KISSIMMEE RIVER RESTORATION STUDY

A LETTER FROM THE CHIEF OF ENGINEERS, DEPARTMENT OF THE ARMY DATED MARCH 17, 1992, SUBMITTING A REPORT TOGETHER WITH ACCOMPANYING PAPERS AND ILLUSTRATIONS, PURSUANT TO SECTION 116(h) OF THE WATER RESOURCES DEVELOPMENT ACT OF 1990

RE: Proposed Kissimmee River Restoration, Final Environmental
Impact Statement and Proposed Modified Level II Backfilling
Plan

FIGURE 20

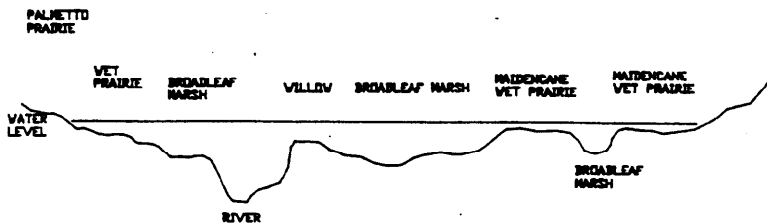
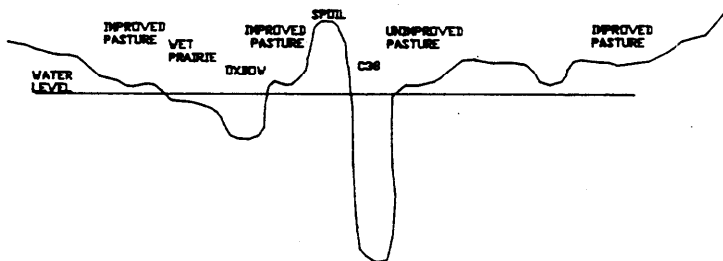
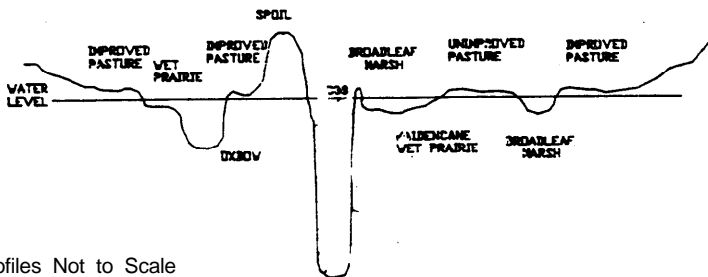
Finally, Figures 18 and 20 need to have a Y-axis and identification of the flow. This would clarify the effect of channelization and altered flow regime.

Comment: Figures 18 and 20 need to have Y-axis and identification of the flow.

Response: Figures 18 and 20 are graphic cross section views that show a profile, or "slice," of the Kissimmee River ecosystem in the central and northern areas of Pool B. Vertical (Y-axis) differences in the profile line display topographic differences across each section; the vertical differences are not to scale.
